BE IT REMEMBERED on the 30th day of April 2012, there was conducted a Special Meeting of the Cameron County Regional Mobility Authority, at the Joe G. Rivera and Aurora de la Garza County Annex thereof, in San Benito, Texas, for the purpose of transacting any and all business that may lawfully be brought before the same.

B. Consideration and Approval of Change Orders #2, #12, #15 and #16 for the SH 550 Project

**3-B CONSIDERATION AND ACKNOWLEDGEMENT OF CHANGE
ORDERS #2, #12, #15 AND #16 FOR THE SH 550 PROJECT**

© CD# 21 FRONTAGE ROADS RE-ALIGNMENT
 PLAN SCALE: 1" = 100' HORIZ.
 PROFILE SCALE: 1" = 10' VERT.

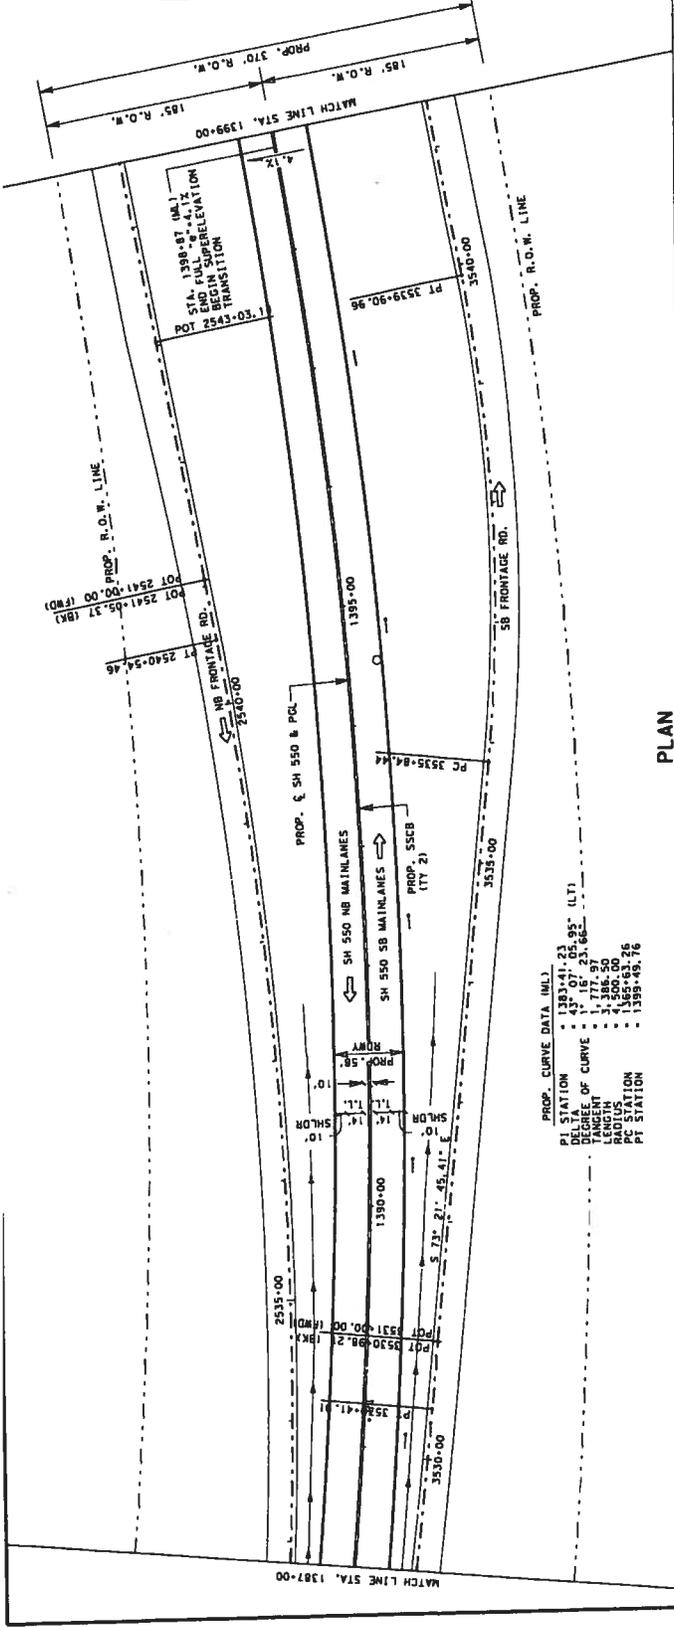
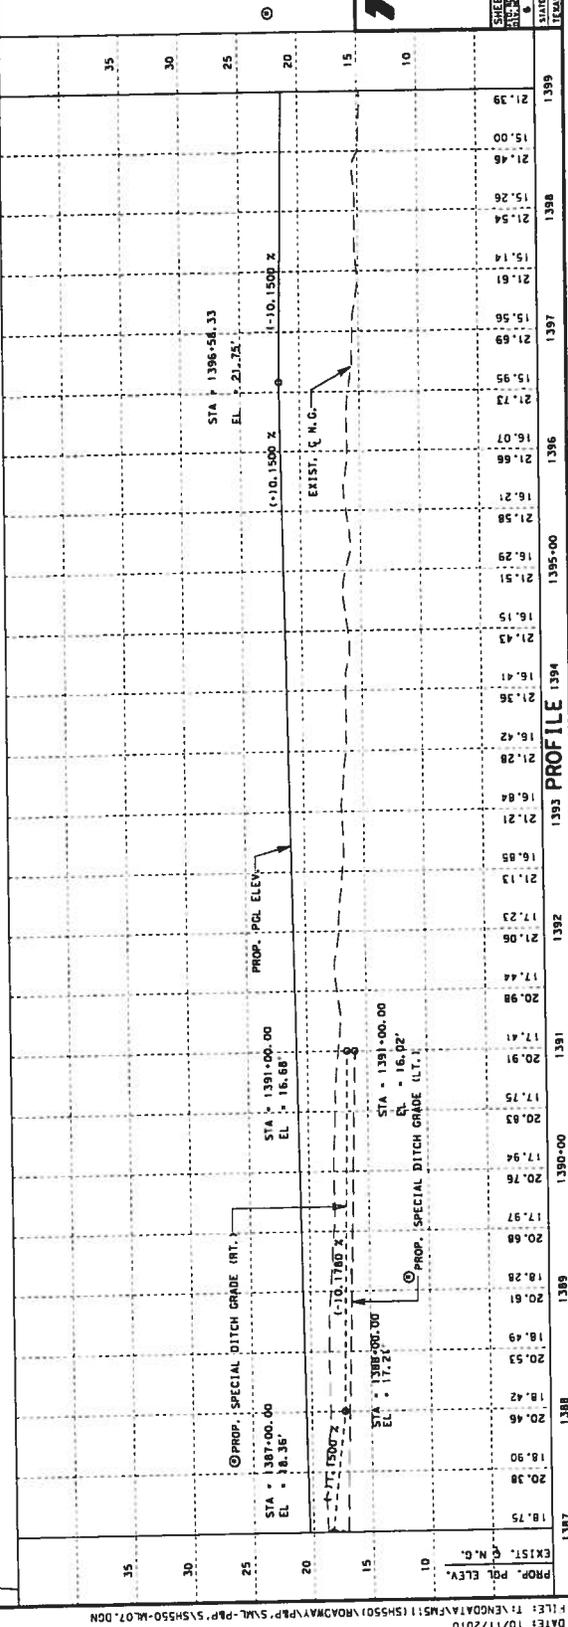
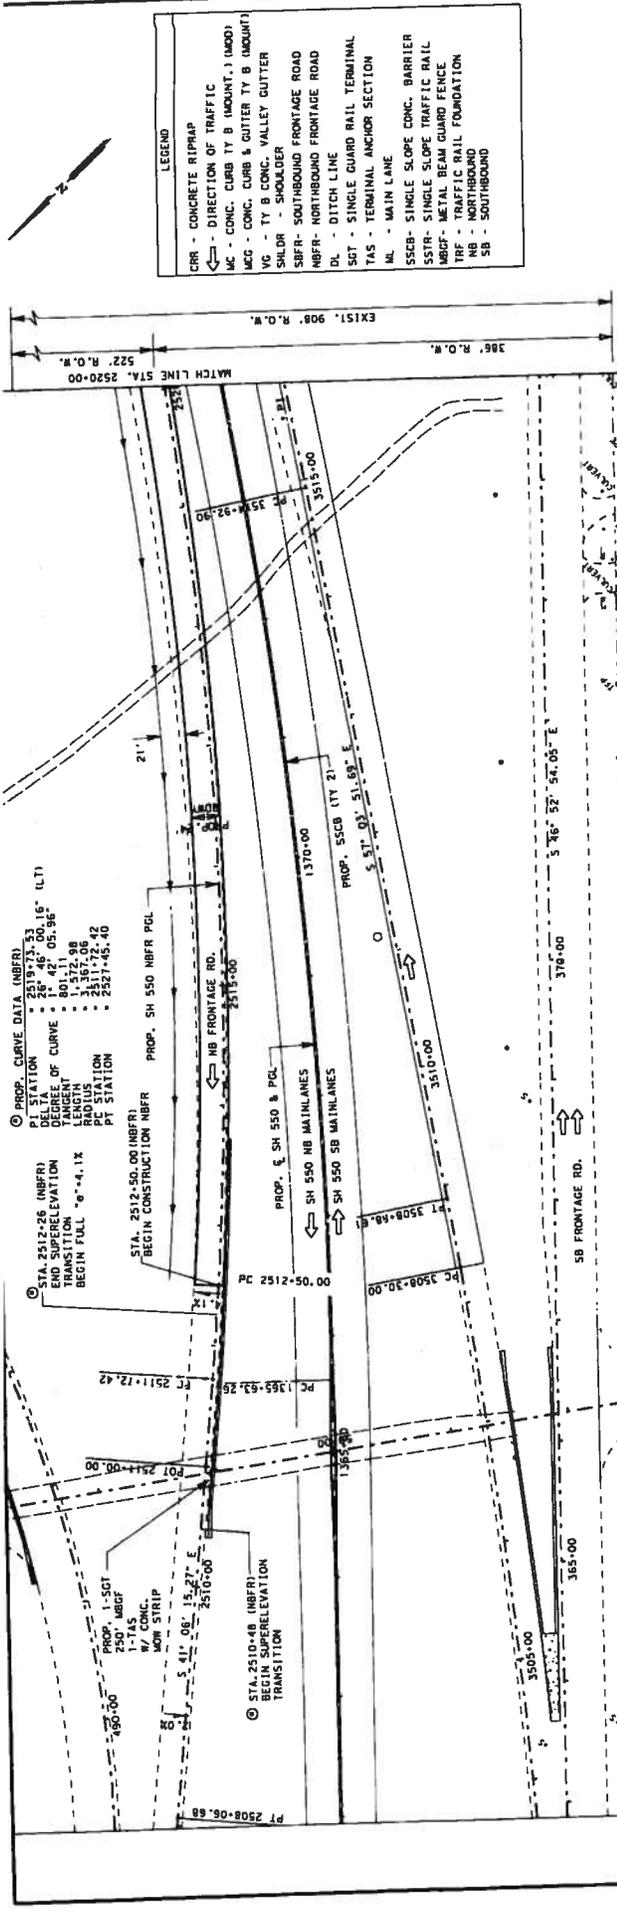
Enclosed for your review is change order # 2 for the above mentioned project. Change order # 2 introduces quantity adjustments to existing and new contract items for the re-alignment of proposed frontage roads under existing FM 511 Northbound Underpass and a proposed equalizing culvert.

Northbound Underpass was recently constructed through the completed FM 511 project. The design for the FM 511 Northbound Underpass does not provide sufficient lateral clearance to allow for the construction of the proposed SH 550 main lanes and frontage roads. TxDOT and contractor field examined existing FM 511 Northbound Underpass header riprap and concluded that the lateral distance between the existing 2:1 slope riprap would not provide the required space needed to safely fit proposed SH 550 frontage roads. Therefore, TxDOT instructed contractor to re-align proposed NB and SB frontage roads going under existing FM 511 Northbound Underpass closer to proposed SH 550 main lanes due to design error. Additional metal beam guard fence, guardrail end treatments, terminal anchor sections, thrie-beams, concrete SSTR rail & foundation, riprap, and mountable curb were introduced to safely divide frontage roads from proposed main lanes and existing Northbound Underpass bridge columns.

CHANGE ORDER# 2: 30" RCP Quantity Adjustment
 REVISION: 1/18/12

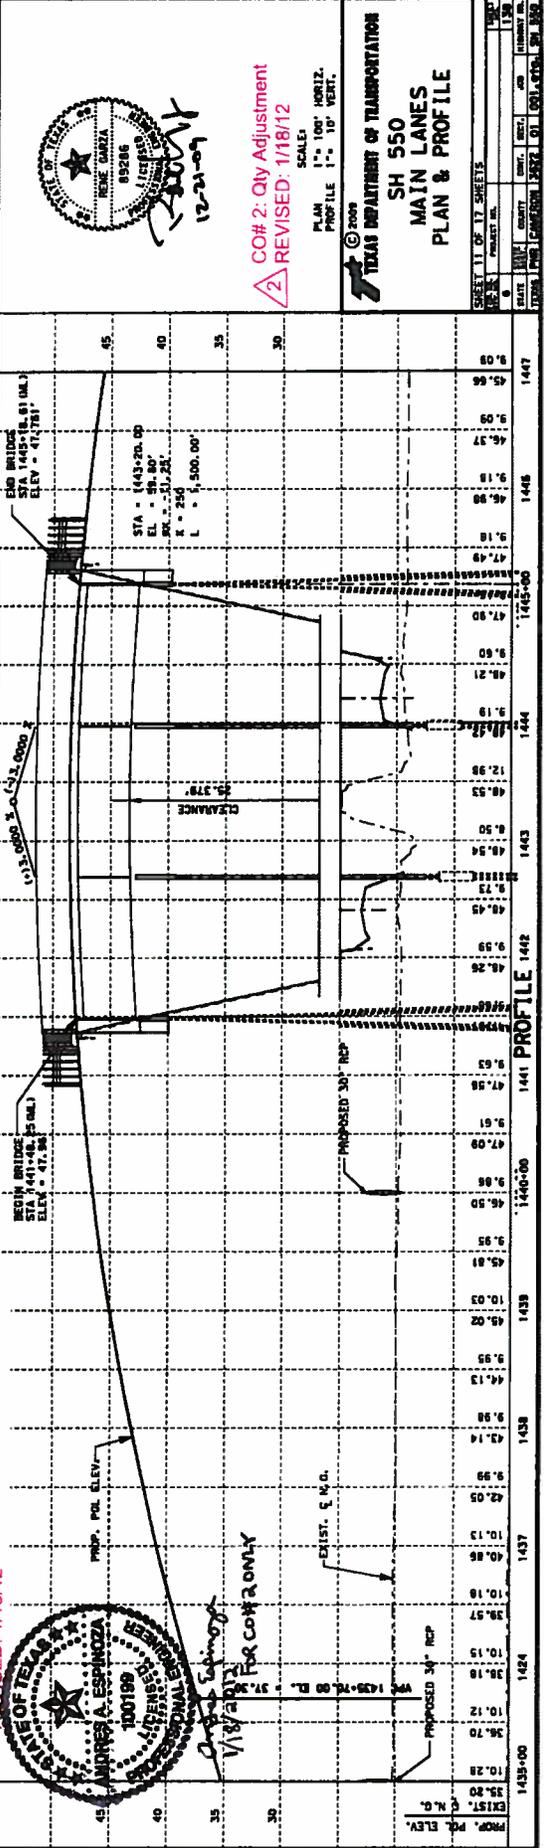
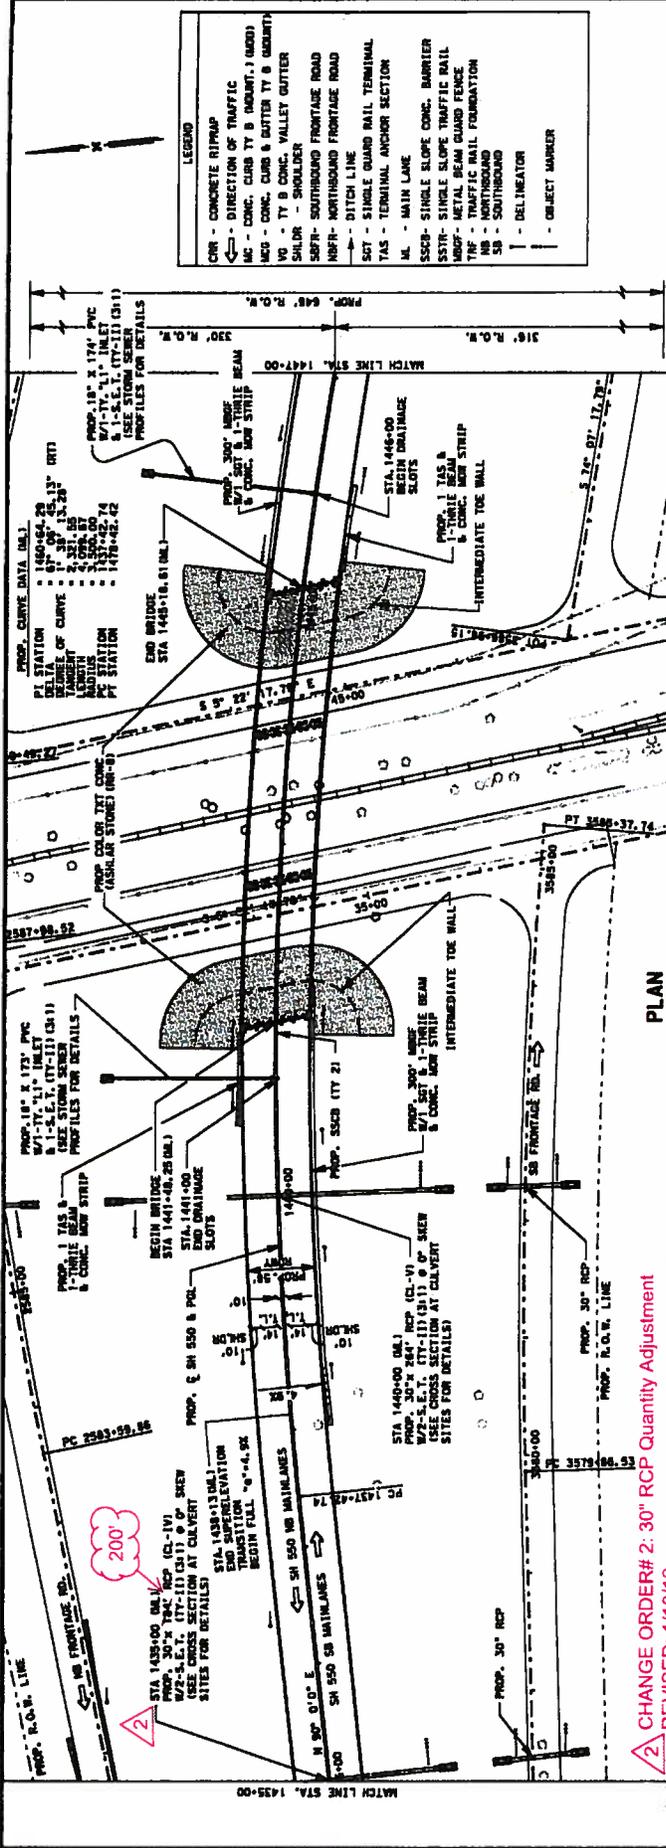
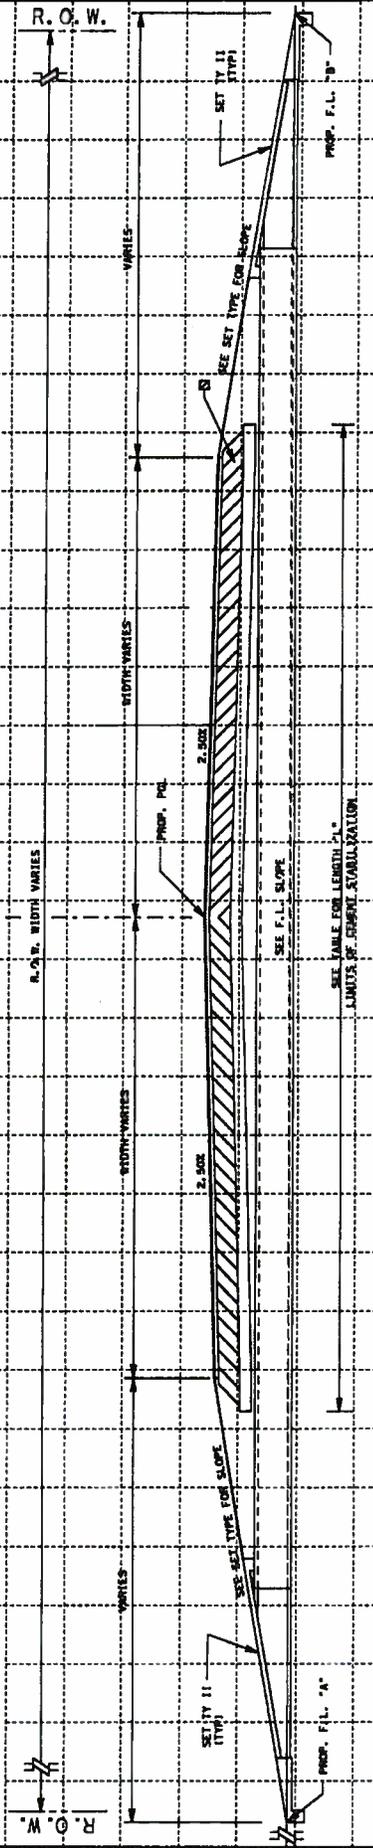
TxDOT instructed contractor to remove & relay two pre-cast Safety End Treatments (SET) and install additional 30" RC Pipe (CL III) for a proposed equalizing culvert located at STA 1435+00 due to design error. Plans call for 30"x184' RC Pipe with SETs across proposed 3:1 embankment slope west of Palo Alto Railroad Overpass. Proposed 30"x184' RC Pipe culvert is too short and will be completely buried within the proposed 3:1 embankment slope. TxDOT field examined proposed culvert location, proposed RC Pipe amount and offset, proposed 3:1 embankment slopes limits, and cross section layouts. TxDOT concluded that an additional 30" X 8' RC Pipe joint was needed at each end of the above mentioned culvert in order to build the proposed 3:1 embankment slope across this culvert.

TxDOT instructed contractor to remove & relay one pre-cast SET and install additional 30" RC Pipe (CL III) for a proposed equalizing culvert located at STA. 3591+64 due to design error. Plans call for 30"x32' RC Pipe with SETs across proposed SBFR road which is too short and will be completely buried within proposed roadway. TxDOT field examined proposed culvert location, proposed RC Pipe amount and offset, and cross section layouts. TxDOT concluded that an additional 30" X 8' RC Pipe joint was needed at the right end of the above mentioned culvert in order to safely build proposed SBFR road.

CHANGE ORDER # 7
MODIFIED STATIONS & OFFSETS,
CHANGED 36\"/>

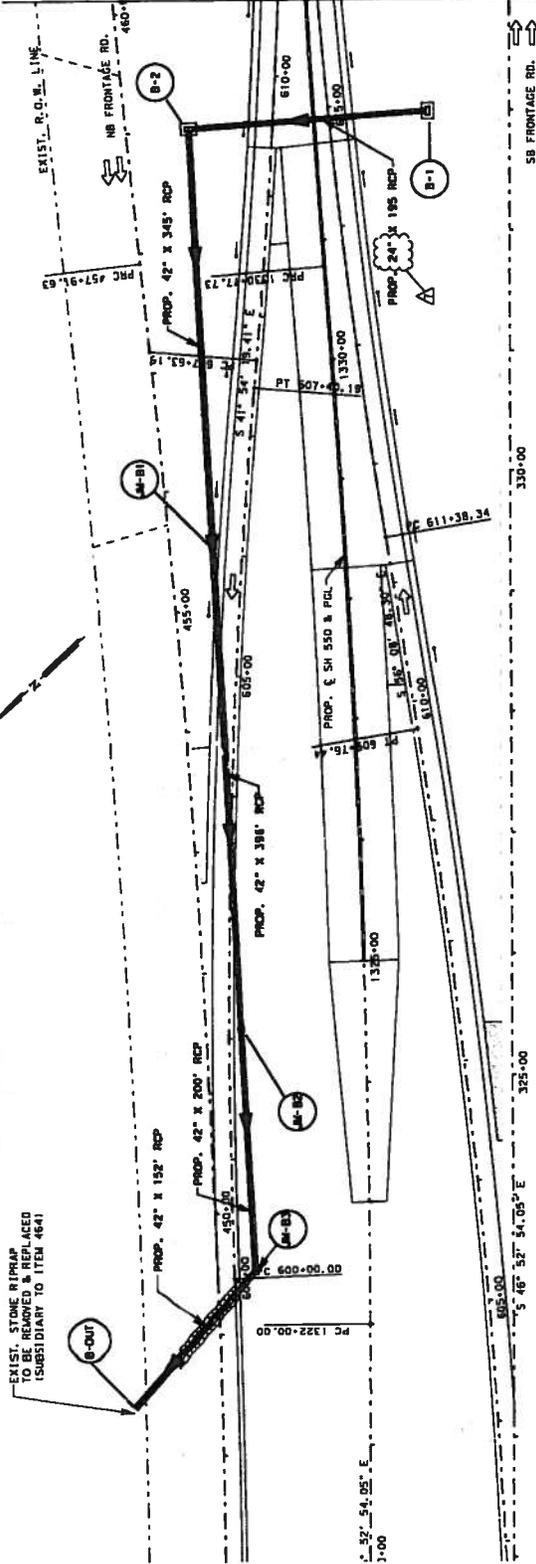
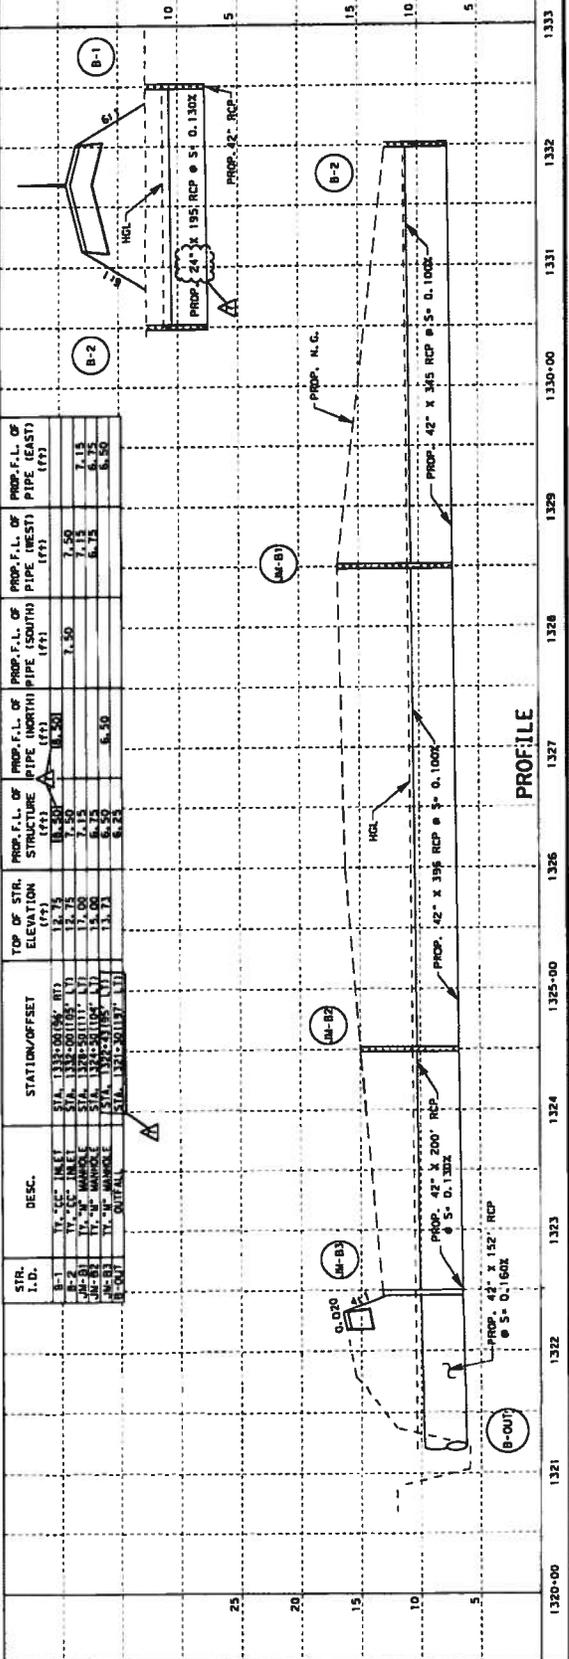
Change Order # 12 proposes to modify existing and proposed drainage provisions at main lane Sta. 1322+00 (north of FM 3248) as a result of a plan error.

When FM 511 was constructed previous to SH 550, 30" RCP (connected to a TY "C") was installed at Outfall No. 2 to provide drainage for this section of the roadway along the northbound frontage (see attached plan sheet# 509 for FM 511). The plan sheets for the current SH 550 project do not account for this previous installation. Instead, the plan sheets for SH 550 propose 42" RCP to be installed perpendicular to the existing northbound frontage road, which is now currently in conflict with the previously installed 30" RCP (installed parallel to northbound frontage). The existing 30" RCP was significantly damaged during the installation (jack and bore) of the proposed 42" RCP, thus prohibiting storm water to drain from the existing TY "C" inlet through existing 30" RCP to existing discharge point. Subsequently, TXDOT instructed the contractor to connect a 30" RCP to the side wall of the existing TY "C" inlet and re-route drainage to a discharge point further downstream at an alignment free of conflict with the proposed 42" RCP (please see Attachment 1). The existing concrete apron for the TY "C" inlet will need to be removed since it will be in conflict with the construction mentioned above. The existing 30" RCP will be plugged at its current connection with the TY "C" inlet. To prevent soil erosion, concrete riprap will be added to the proposed 42" RCP and the newly installed 30" RCP at Outfall# 2.

Plans call for contractor to install proposed 36"X195' RC Pipe (CL III) from proposed TY "CC" inlet (B-1) to TY "CC" inlet (B-2) at main lane STA. 1332+00. Proposed 36" RC Pipe does not fit into pre-cast TY "CC" inlets. TXDOT decided to down size proposed RC Pipe from 36" to 24" in order to make pipe fit into proposed pre-cast TY "CC" inlets. Furthermore, plans call for the wrong station/offset location for TY "M" manhole (JM-B3) and outfall (B-OUT). Proposed storm sewer structure quantities at the above mentioned location are not affected by this error.
